Re: Z-15-005 - Laurel Hill Valley Citizen's Association 2nd Open Record Submittal

LHVC Annotation on Applicant's Map ZC-4 (9/2/15 Version)

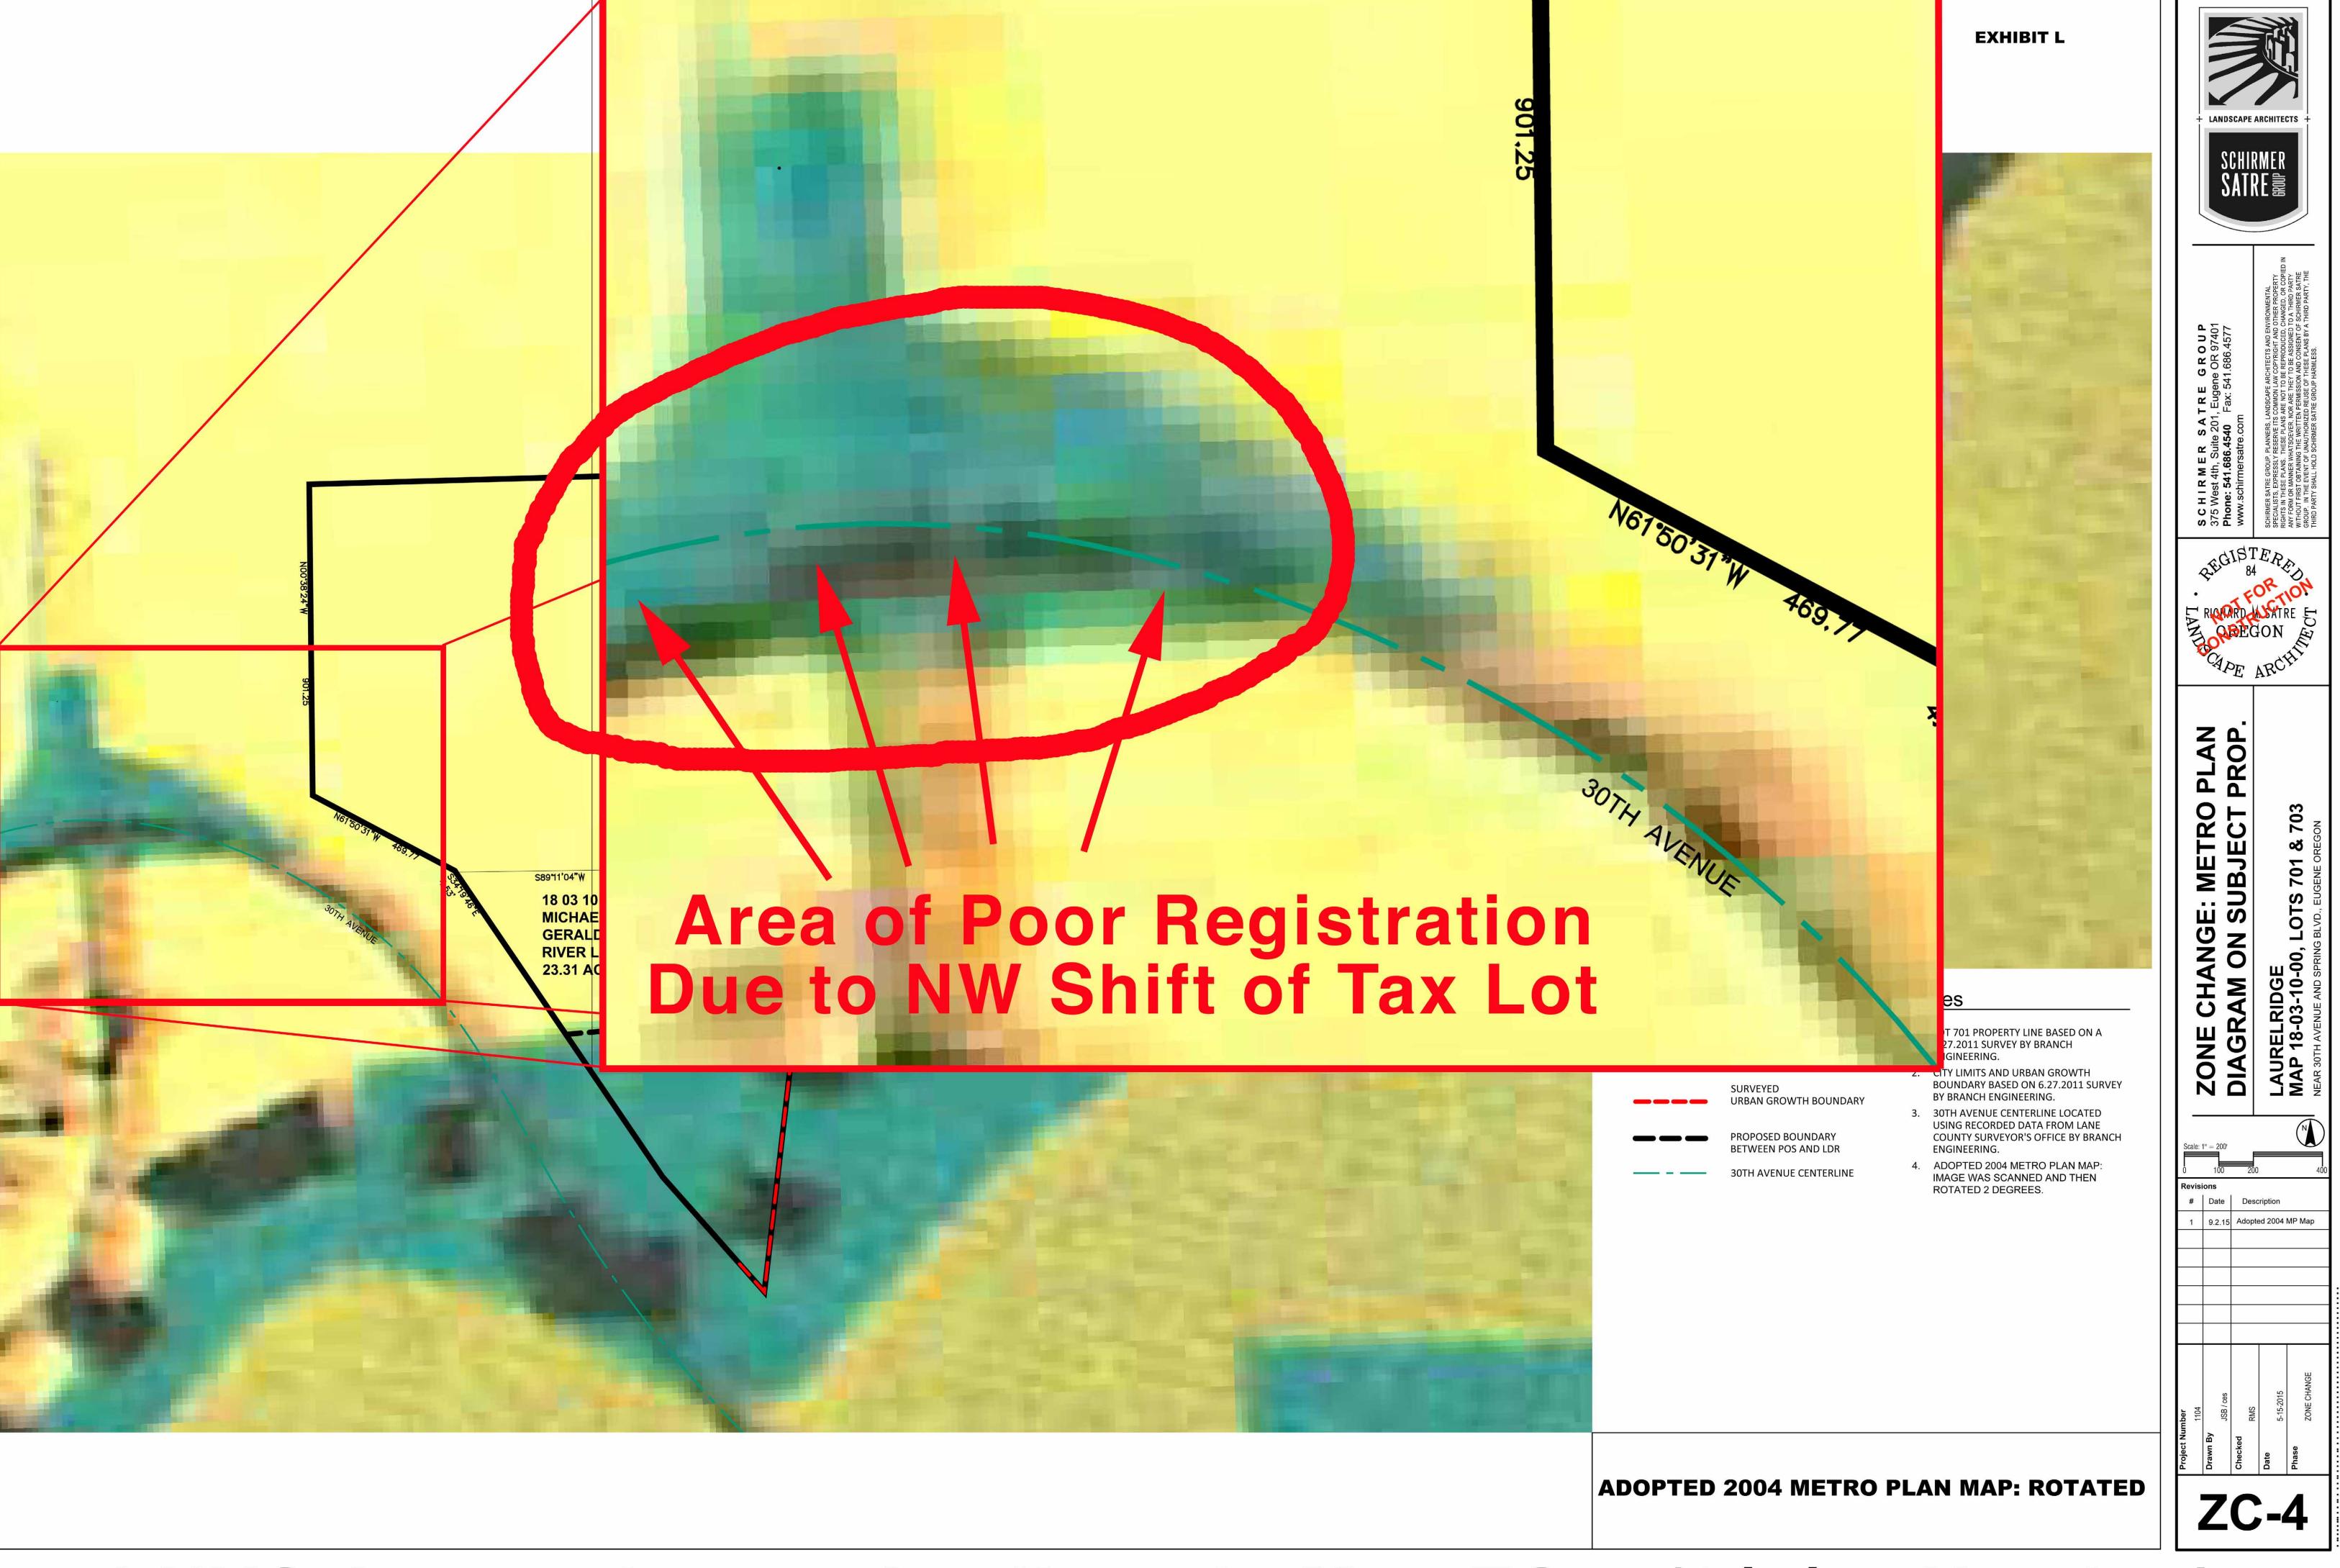
Any reputable land use consulting firm tasked with this determination would use the maximum number of possible referents to constrain the limits of the POS on the subject property. Schirmer-Satre decided that the absolute minimum number of referents (one) is more to their liking. Moreover, even using <u>only</u> the 30th Avenue center-line, after recently removing the City Limits and UGB from their survey map, the applicant's registration of 30th Avenue is still abominable, especially in the westernmost area (see attached Figure with an enlargement of the pertinent portion of the applicant's map).
